| Model: Martini-C3 | Date: 01-Sep-06 | No.: RB246001c |

| Subject: Firmware Release History (Engine)        |  | Prepared by: S. Watanabe                           |  |

This RTB has been issued to announce the firmware release information for the Engine.

### 3. Elimination of the fusing lamp for side heating

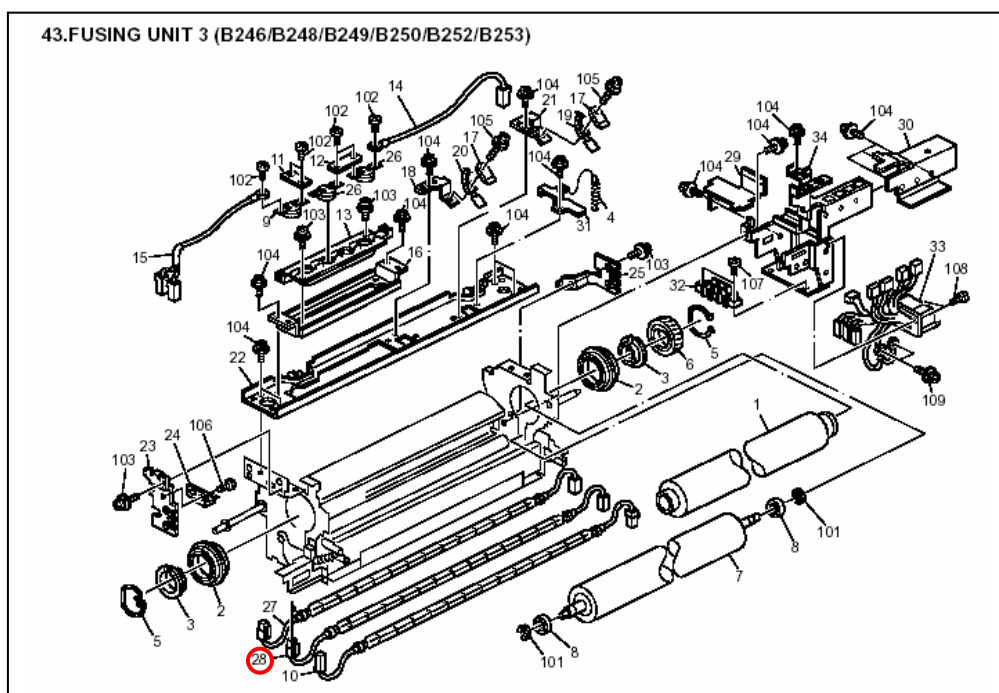
The lamp for side heating (listed in the MT-C3 Parts Catalog on pg. 99, item 28) was eliminated on the MT-C3.5c. This is because the warm-up time on this model (60 sec.) is 30 seconds slower than on the MT-C3 (30 sec.), and as a result, there is no need to provide additional heat to the roller ends. It has been confirmed that eliminating this lamp does not affect image quality. This change will make it easier to replace/install fusing rollers in the field.

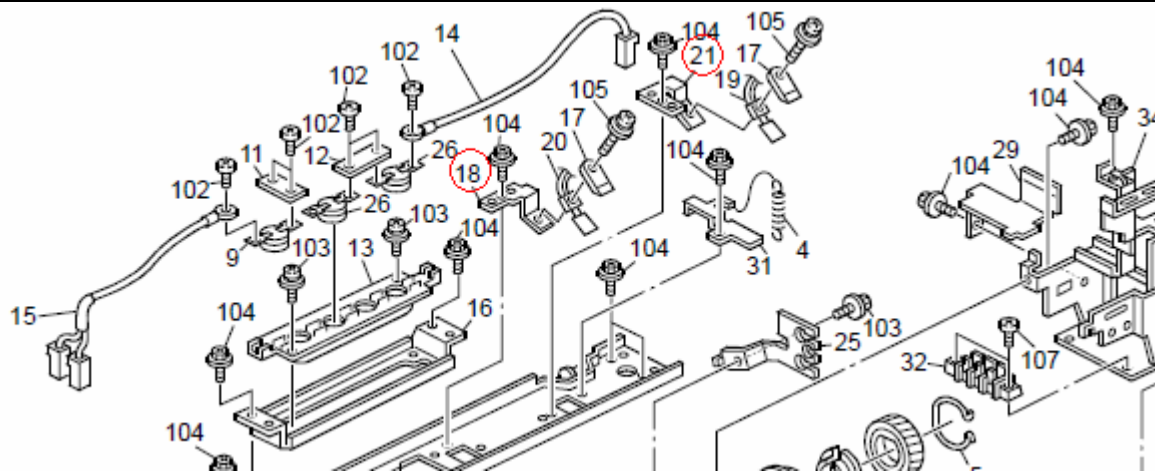
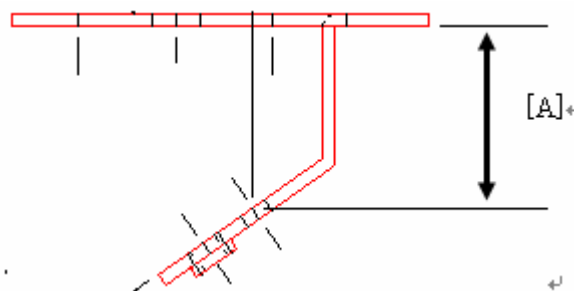
1. Clean the middle and rear thermistors.
2. If the SC still occurs even after cleaning the thermistors, replace the thermistor brackets with the new parts in the table below.

**Note:** This will secure the thermistors in the correct position, ensuring that they can detect the roller temperature correctly.

**B1404196/7: 14.8mm**

**D0624196/7: 15.3mm**

| Old part number | New part number | Description                   | Q'ty | Int             | Page | Index | Note |
|-----------------|-----------------|-------------------------------|------|-----------------|------|-------|------|
| B1404197        | <b>D0624197</b> | BRACKET:THERMISTOR:MIDDLE     | 1    | X/O<br>As a set | 99   | 18    |      |

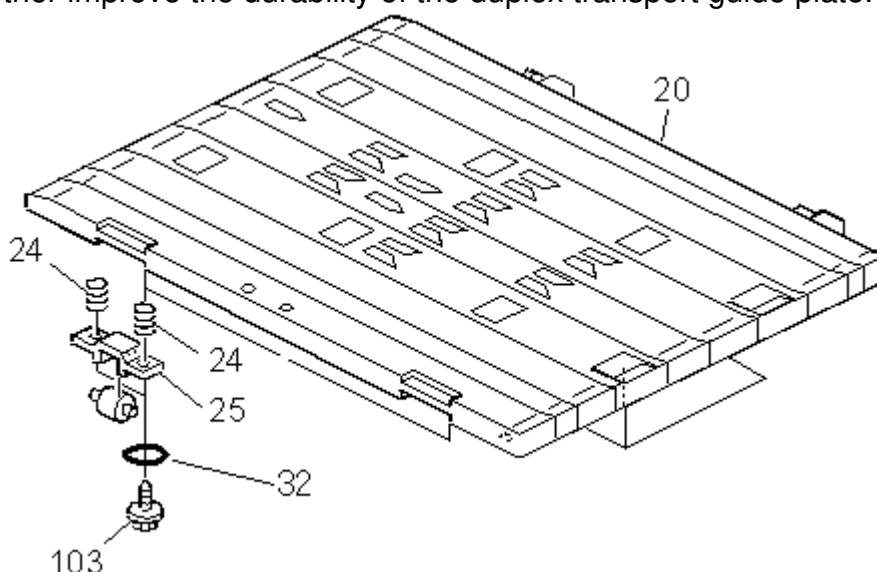
1. The thickness of the duplex transport guide plate was increased.
2. The diameter of the spring was increased.
3. A spacer was added.

| Old part number | New part number | Description                            | Q'ty | Int          | Page | Index |
|-----------------|-----------------|--|------|--------------|------|-------|
| B0654730        | D0624730        | GUIDE PLATE:TRANSPORT:LOWER            | 1    | X/O as a set | 119  | 20    |

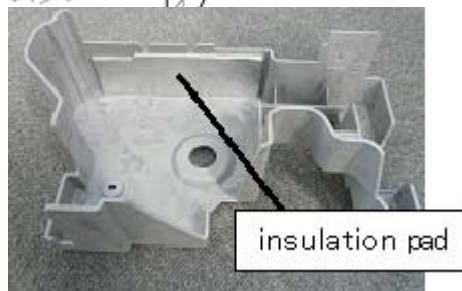
3. Attach the extra insulation pad (B0654255).

Note: This will prevent heat from being transferred from the fusing unit to the toner bottle.
